STATE OF CONNECTICUT  
CONNECTICUT SITING COUNCIL

IN RE: :  
 :  
APPLICATION OF NTE CONNECTICUT, : DOCKET NO. 470  
LLC FOR A CERTIFICATE OF :  
ENVIRONMENTAL COMPATIBILITY AND :  
PUBLIC NEED FOR THE CONSTRUCTION, :  
MAINTENANCE AND OPERATION OF AN :  
ELECTRIC POWER GENERATING :  
FACILITY OFF LAKE ROAD, KILLINGLY, :  
CONNECTICUT : OCTOBER 27, 2016

APPEAL OF AND RESPONSES TO THE  
MUNICIPAL REGULATE AND RESTRICT ORDERS

**Revised Figure 2-4  
KEC Site Layout and  
Grading**

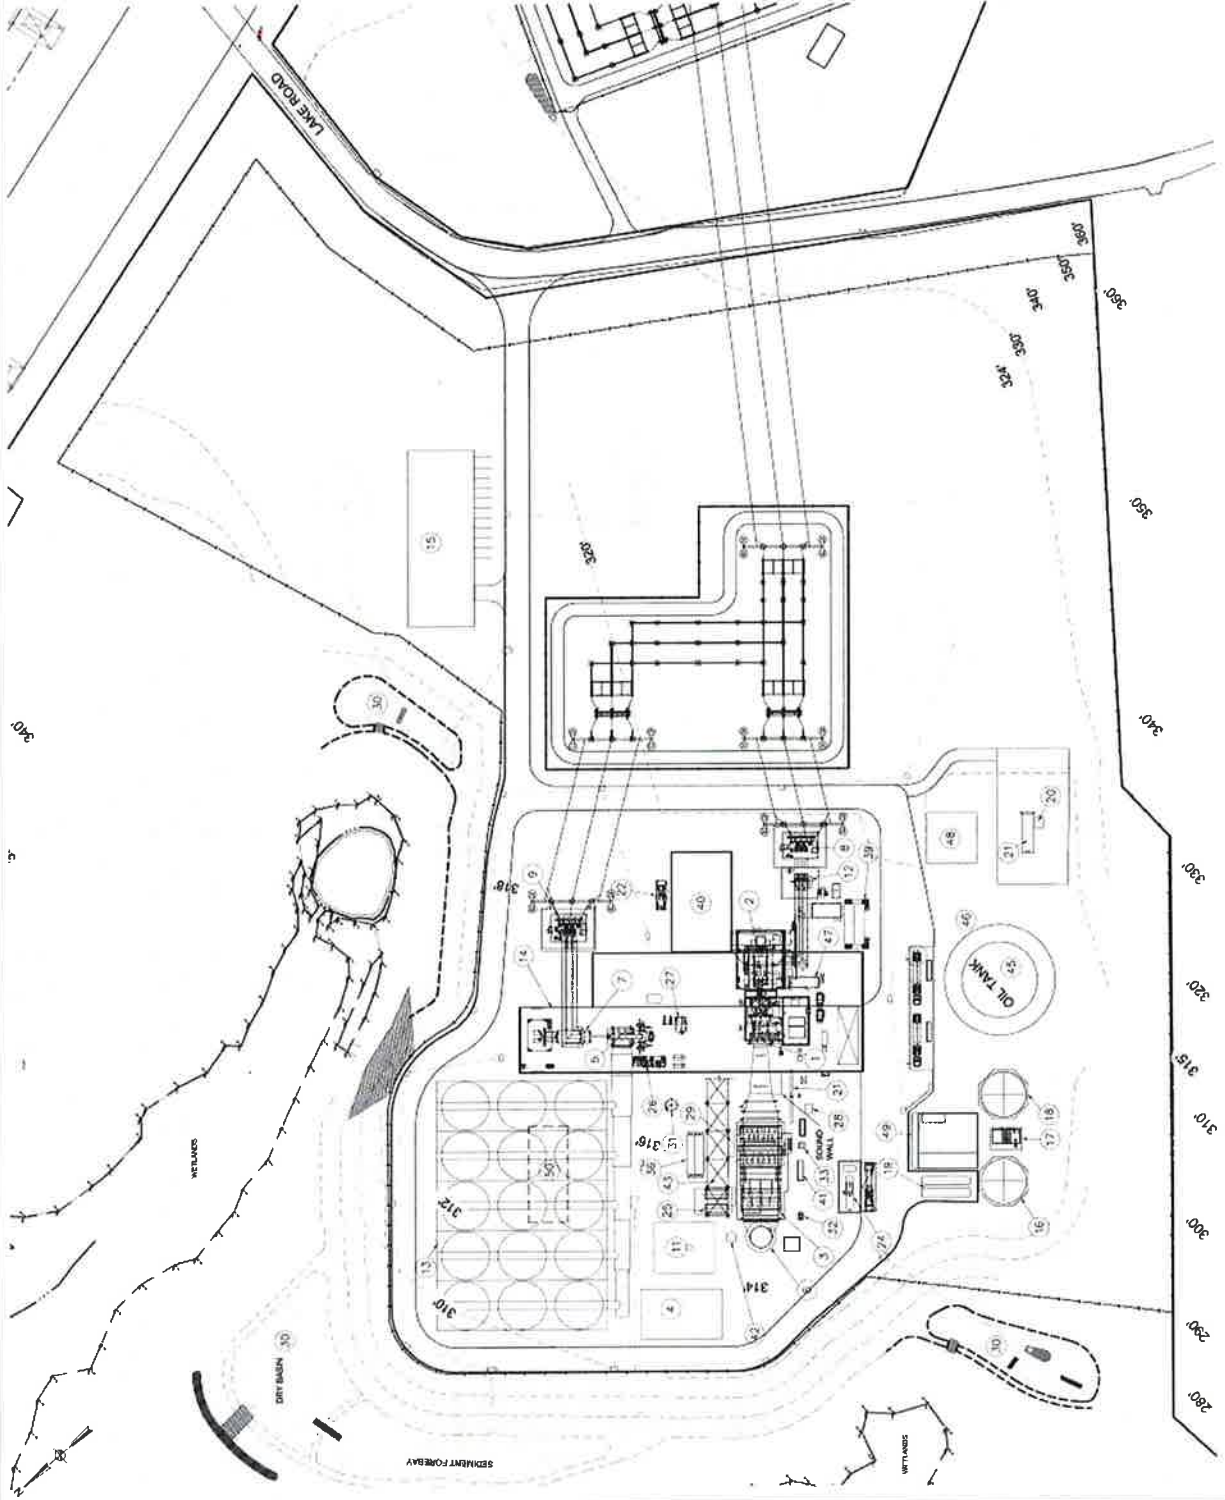
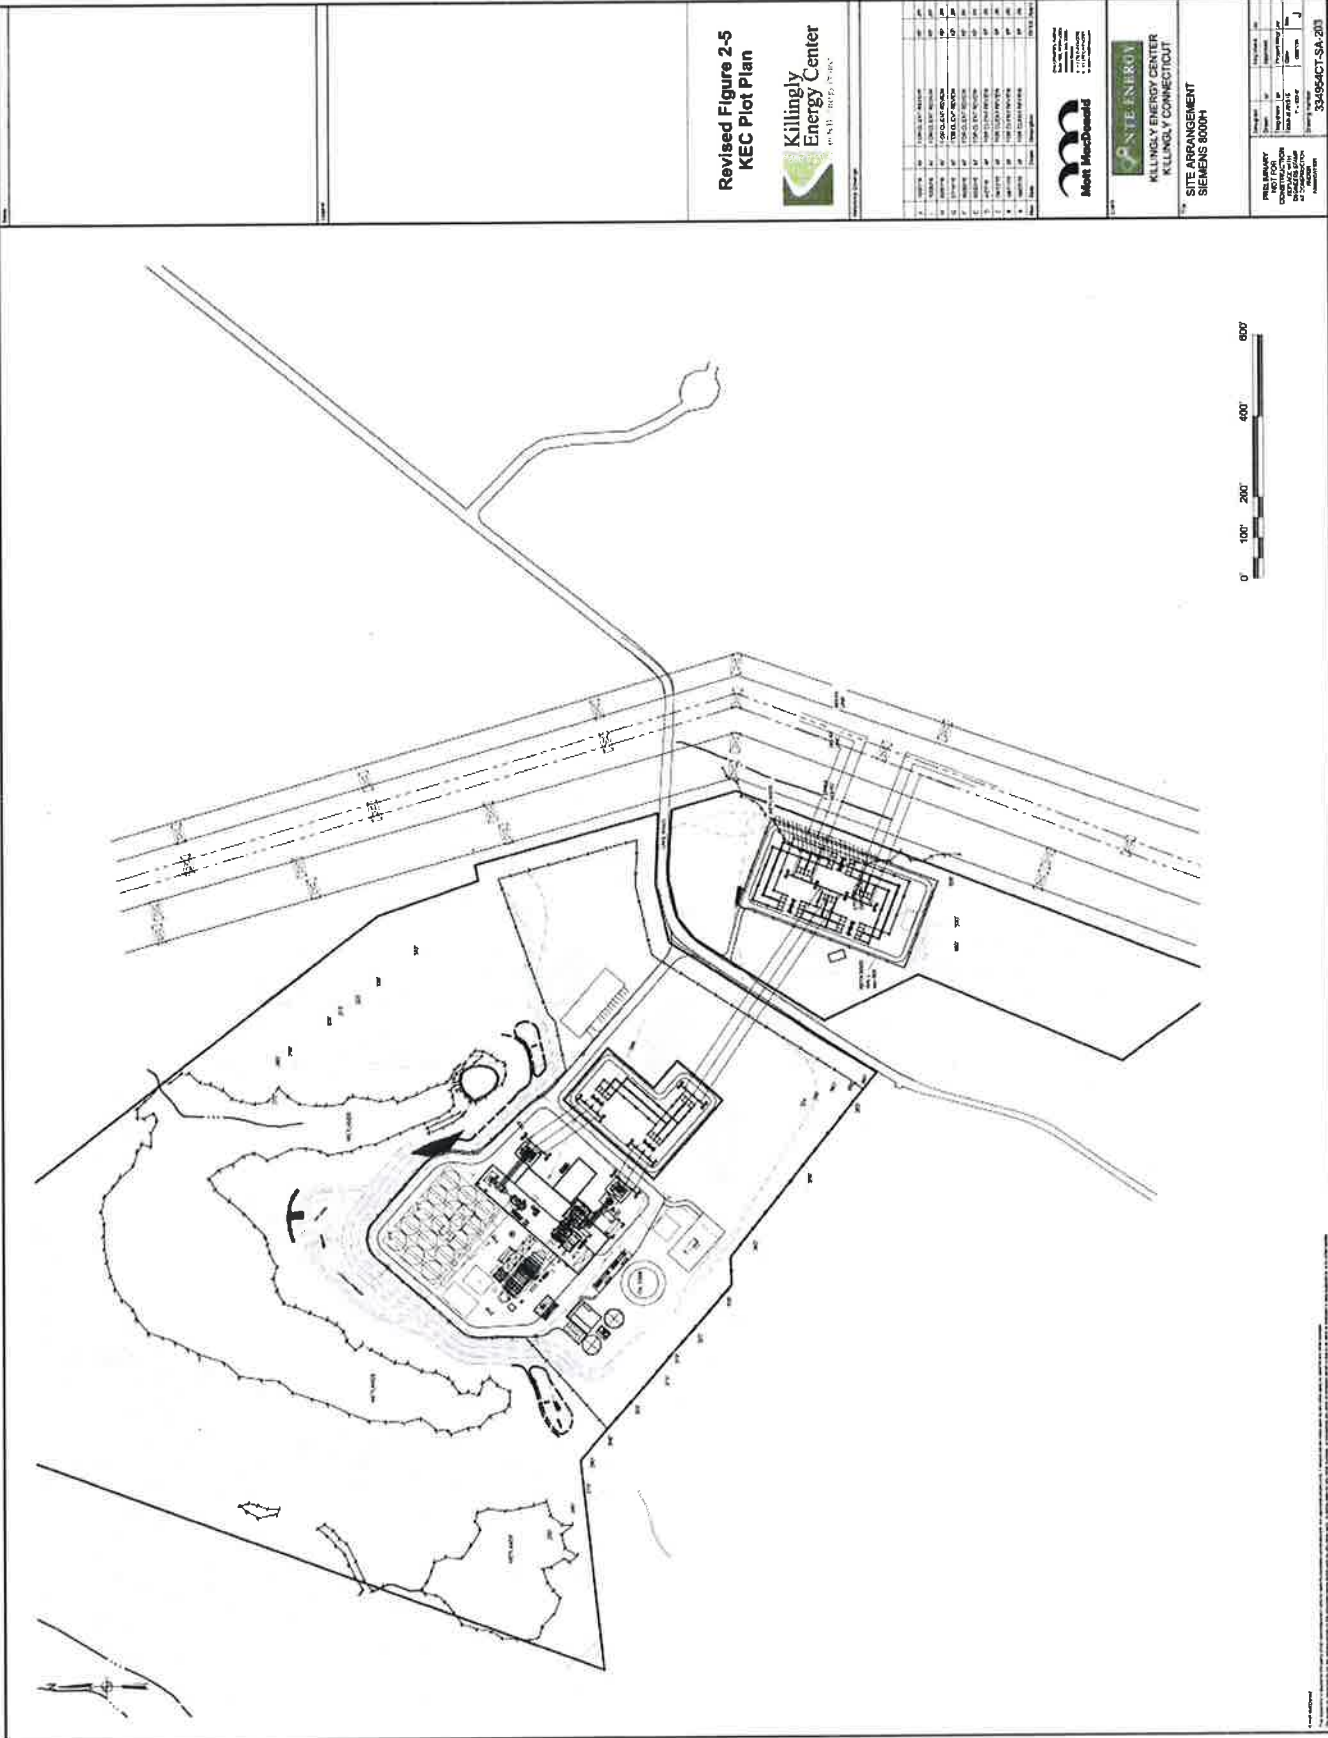
1. Based upon the outlet of the proposed drainage structure and regrading of the site, there is concern that wetlands A1, A3, and X will not receive adequate overland flow resulting in their destruction. A potential solution to this concern is described in the “Recommendations for CSC Conditions and Third Party Review” by TRC Environmental Corporation (TRC) as:

- Within the main plant parcel, move the limits of all grading activities, clearing and disturbance a minimum of 75 feet from all wetland boundaries and maintain the tree canopy in this zone.
- The location of the administration building, compressor station, main plant facility, tanks and other site features shall be moved to accomplish the required separation.

**The primary storm water basin has been reassessed to incorporate a crushed stone layer into the design to encourage further infiltration. Two additional basins at the headwaters of Wetland A1 and A3 have been added and incorporated into the storm water design (See Exhibit 3 - Revised SWPPP and Exhibit 5 - Updated E&S Plan). The two additional basins will also incorporate a crushed stone layer to encourage infiltration. Further, NTE will provide an infiltration mechanism as recommended (i.e., a crushed stone trench) between the two new additional basins and wetlands A1 and A3, respectively. NTE has verified that the two additional basins, two additional crushed stone trenches, and the addition of crushed stone to all three basins will allow for more than the recommended infiltration volume. Therefore, NTE APPEALS the limited portion of the order calling for the installation of a trench between KEC’s limits of grading and the entirety of wetlands A1 to A3.**

**The majority of KEC layout was located more than 25 feet from wetlands, with the exception of the very tip of Wetland A3 (which came within 20 feet of proposed grading) and the area where a retaining wall was constructed to avoid impact to Wetland X. However, in response to this order, certain elements (i.e., air cooled condenser, gas compressor building, ring road) on the Generating Facility Site have been relocated or reconfigured to increase the separation distance from all wetlands boundaries to a minimum of 25 feet as required by the Town IWWC Regulations (See Exhibit 2 - Revised Site Plan). NTE has increased that separation distance/buffer further, to comply with the requested 75-foot separation, where feasible. Side slopes on the Revised Site Plan are predominantly 2:1 and will be vegetated; the only location where a 1:1 slope is required is a 2,500-square foot area adjacent to Wetland X where that steeper slope is required to comply with the 25-foot no disturbance buffer from Wetland X as defined in the Killingly IWWC Regulations. For this limited area, NTE APPEALS that portion of the order calling for a maximum 2:1 slope. Instead, rip-rap will be employed in this limited area for**

Revised Figure 2-8  
Details of Electric Transmission  
Interconnection

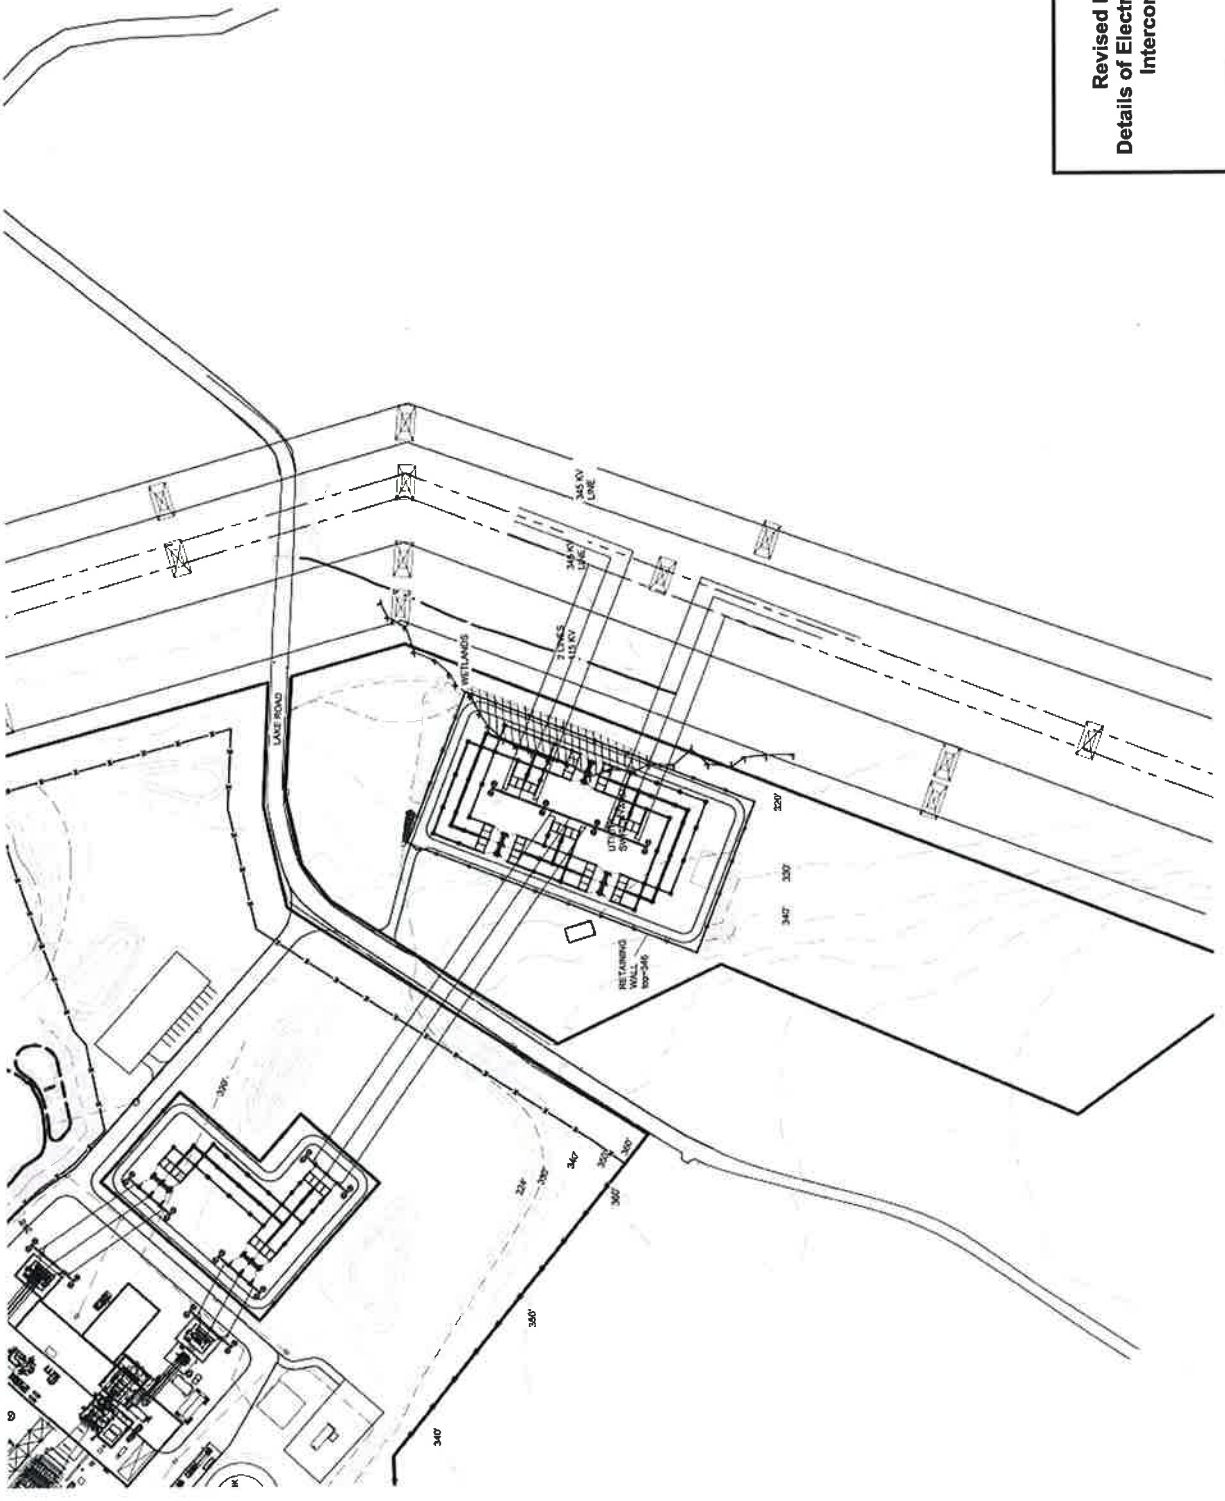
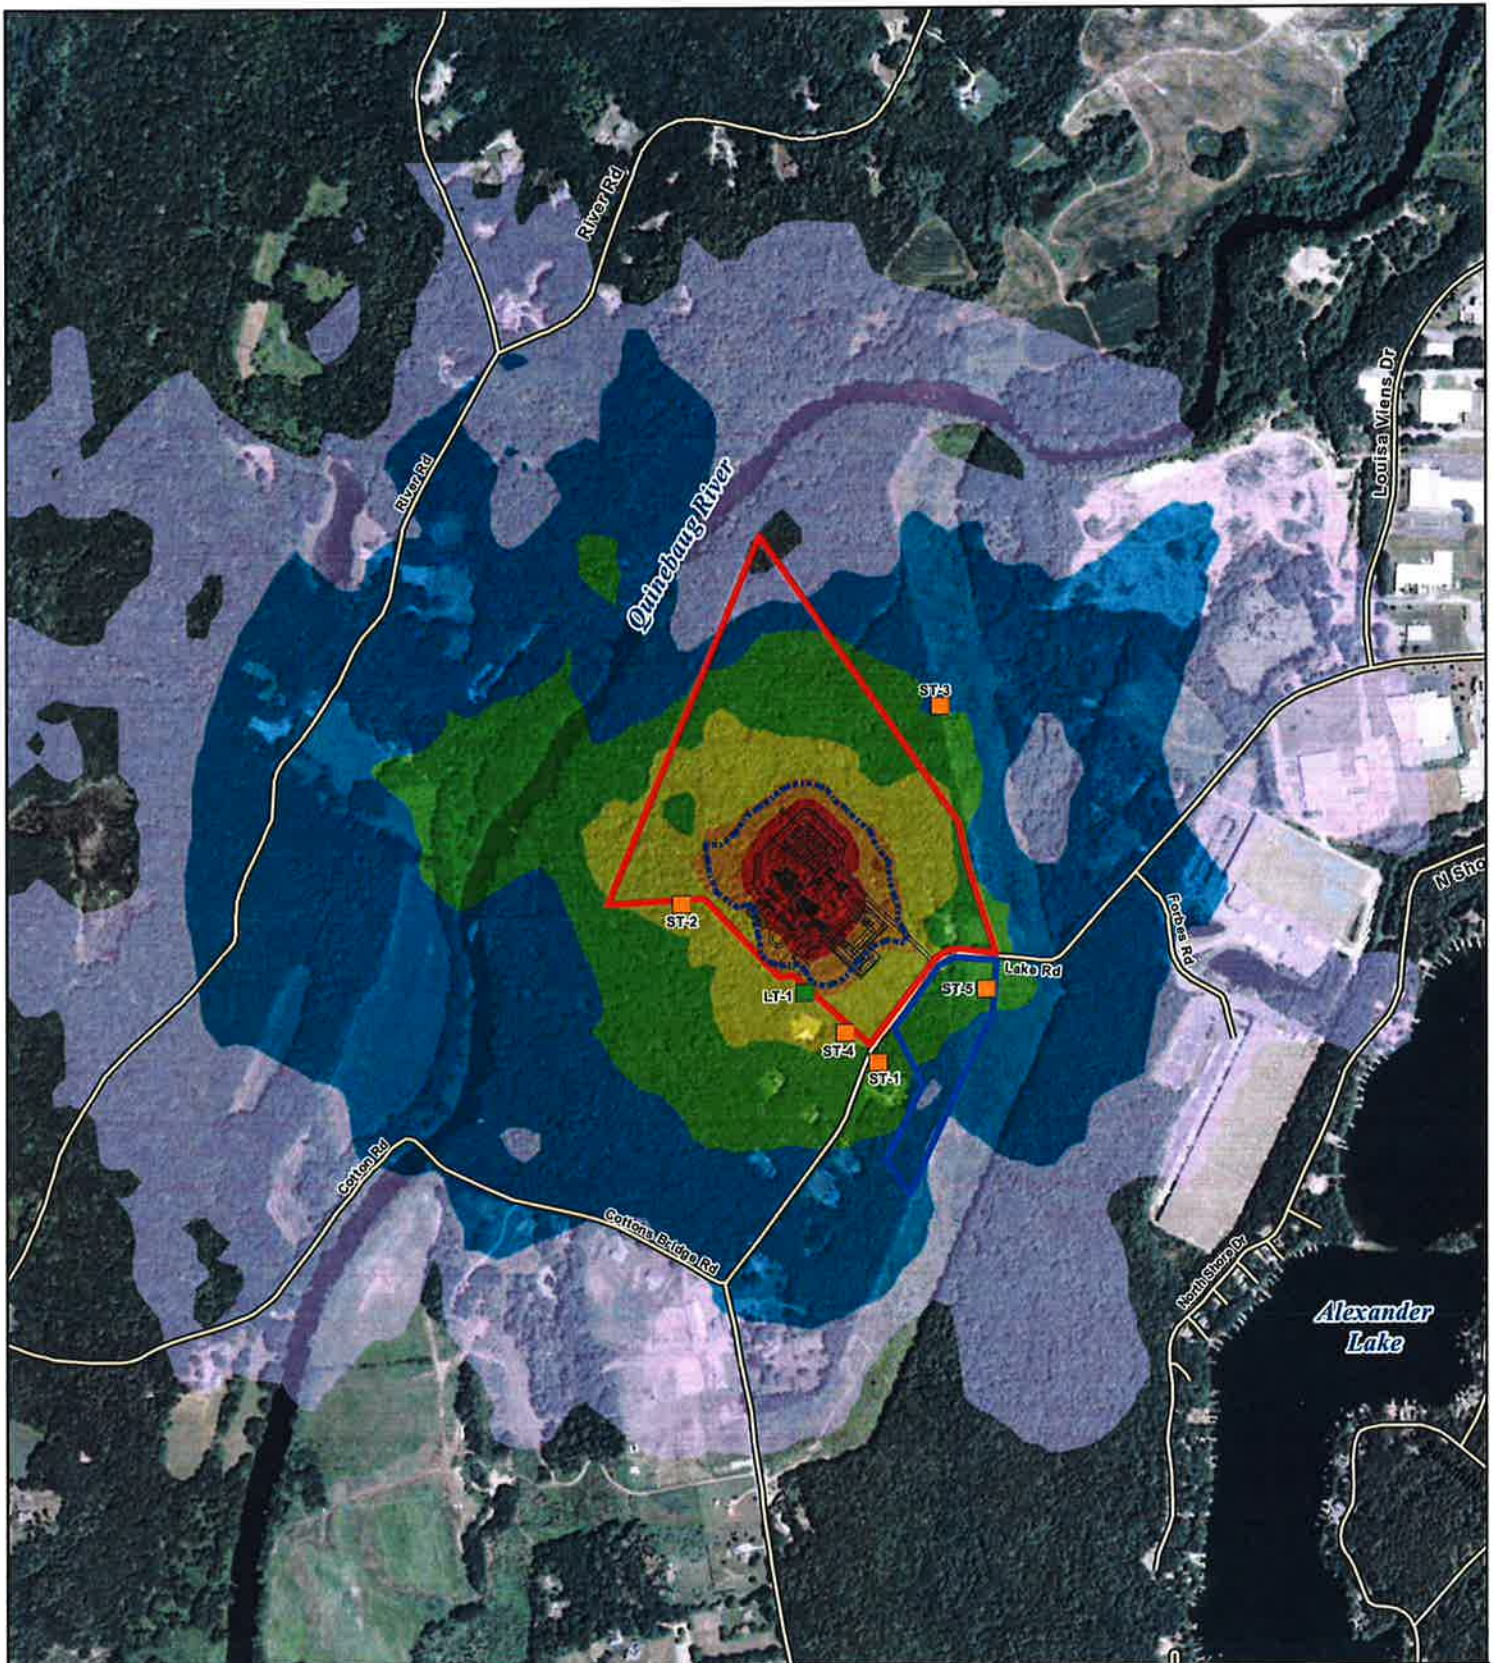
3) No permanent access is shown on any plans with regard to the switchyard if the switchyard stays on the southern side of Lake Road. This is a concern for public health, safety, and general welfare.

**Permanent access to the switchyard site is shown on the original site plan included as a part of the NTE Application on Figure 2-8.**
